210513 - Motor Requirements for Fire Suppression

Shop Drawing Submittal Review

Project Name: Webster University-**ISB**

SPECIFICATION SECTION: 210513
Common Motor
Requirements for
Fire Suppression
Equipment

(H)8x6x12F – 8100 SERIES

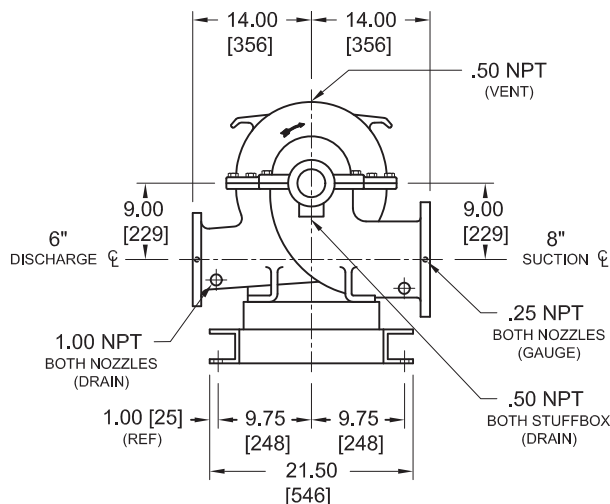
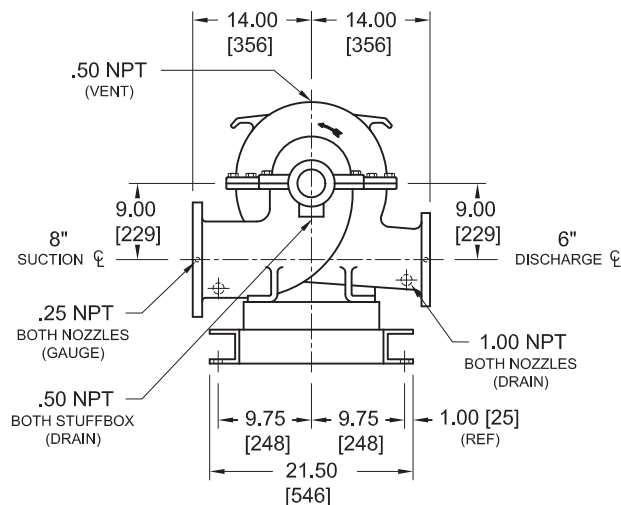
Reviewed for motor only

NO EXCEPTION TAKEN					
MAKE CORRECTIONS NOTED, NO RESUBMITTAL:					
AMEND AND RESUBMIT					
REJECTED, SEE REMARKS:					
REVIEWED ONLY					
NEC	MCN	AAR	REJ	REV	ITEM
				X	A-C Fire Pump Systems Series 8100 40 HP, 460 volts, 3 phase
					REMARKS
					1. Reviewed for motor only under this submittal.
This submittal is to be reviewed by the Electrical Engineer for electrical characteristics and compliance.
